**LEVY NUCLEAR PLANT, UNITS 1 AND 2
DOCKET NOS. 52-029 AND 52-030
SUPPLEMENT 5 TO RESPONSE TO REQUEST FOR ADDITIONAL INFORMATION LETTER
NO. 086 RELATED TO FOUNDATIONS**

**Levy Nuclear Plant Units 1 and 2
Supplement 5 to Response to NRC Request for Additional Information Letter No. 086
Related to SRP Section 03.08.05 for the Combined License Application,
Dated March 16, 2010**

NRC RAI #: 03.08.05-07

Progress Energy Florida
 Levy Nuclear Plant
 Units 1 and 2
 Part 2, Final Safety Analysis Report
 DRILLED SHAFT LAYOUT FOR TURBINE,
 ANNEX, AND RADWASTE BUILDINGS
 FIGURE RAI 03.08.05-07-1 Rev 2

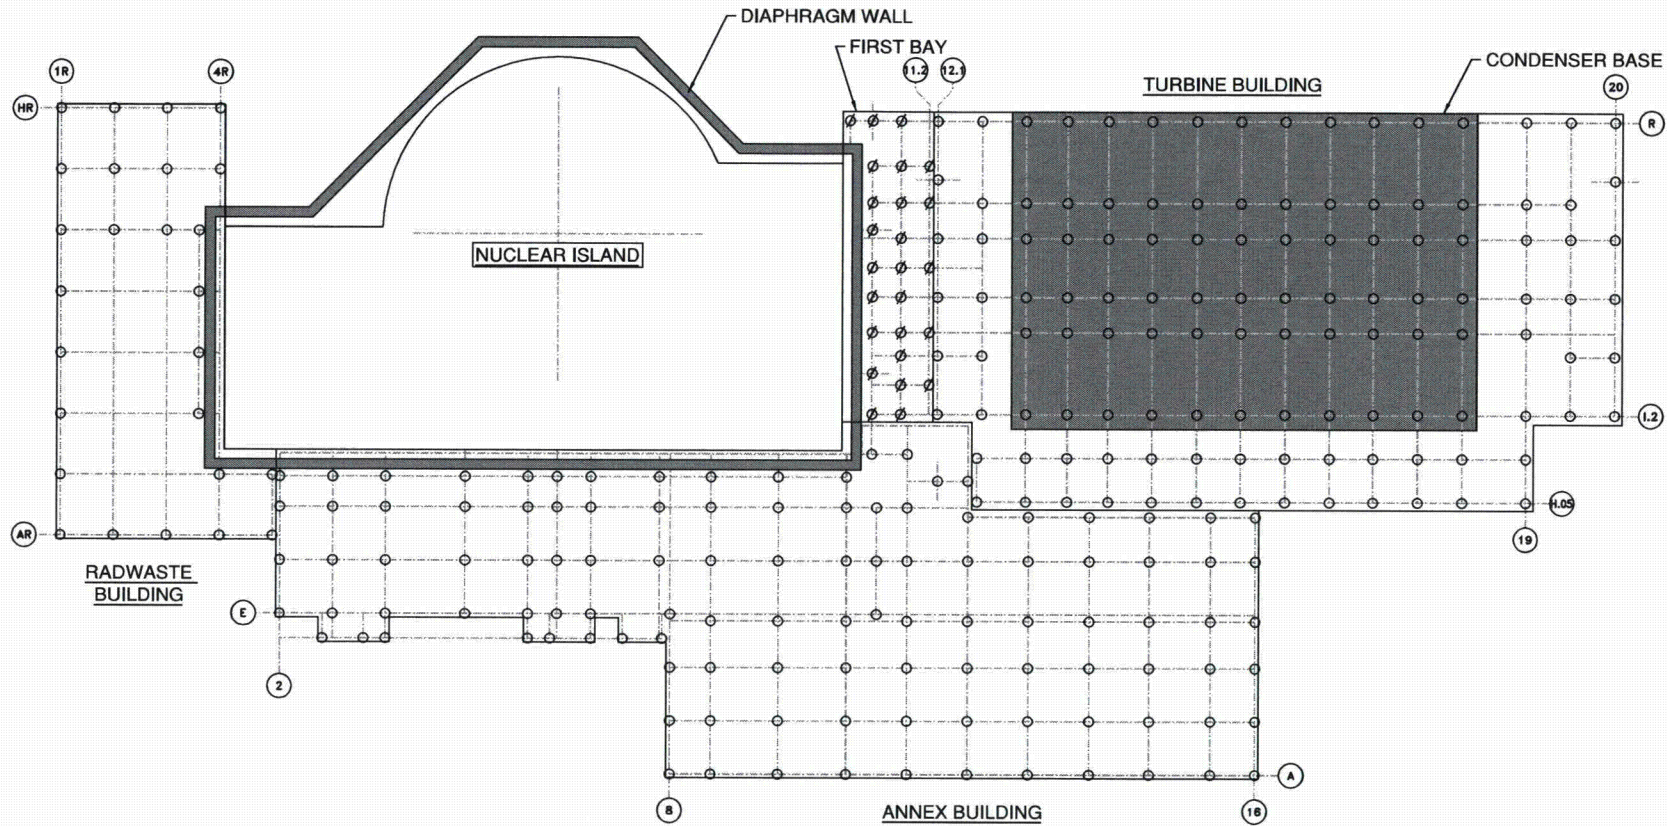
1. It does not appear from the description provided in Part 1(d), that the effects of drilled shaft -to- drilled shaft interaction are considered. Interaction will reduce the stiffness of the foundation, thereby increasing the displacement to be expected. Discussions between the applicant and the NRC staff indicate that the design of these foundations are not complete, however, it has been assumed that the drilled shaft spacing will be sufficient to preclude interaction. Since the spacing and size of the deep foundations have not been developed, the potential effects of interaction cannot be dismissed out-of-hand. Please indicate the procedure(s) that will be used to assess the significance of the interaction effects between the drilled shafts in final design.

2. The description of application of loads to the pile group indicates that displacements were computed for the application of the inertial loading to the top of the piles. An additional source of relative displacement between the adjacent structures and the nuclear island, that appears to be neglected, is any additional displacement that may be developed from the soils along the sides of the RCC mat, including the engineered fill. This displacement will occur between the base of the RCC mat and the top of the soil corresponding to the elevation of the top of the pile foundation. See the attached sketch. Please provide the basis for neglecting this displacement including an estimate of its magnitude.

1. Figure RAI 03.08.05-07-1 has been revised to show the new layout for the RB drilled shaft foundation. The 3 ft. diameter drilled shafts under the RB have been revised to 4 ft. diameter drilled shafts.

Revised Figure RAI 03.08.05-07-1, as shown in the attachment, will be added to the FSAR (referenced in FSAR Subsection 3.8.5.9).
